Access Compliance Report

Public Rights-of-Way

(Curb Ramps)

Intersection ID: 9316	Main Street: KARENSTONE_DR	Cross Street: THE_PLAZA	Location: SE
ADA ID: 3513E7600814	Ramp Type: BlendTrans1	Initial Pass/Fail: Fail	Overall Compliance: No
		Severity Score: 8.75	
Codes/Mitigation Info/Possible Solution		Field Measurements/Component Compliance

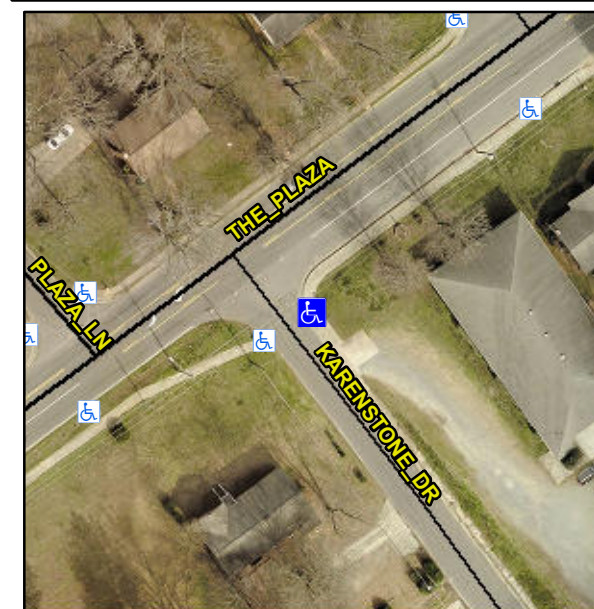
Not Found, R304.5.1

Remove & Replace Curb Ramp With Two New Directional Ramps or Equivalent.
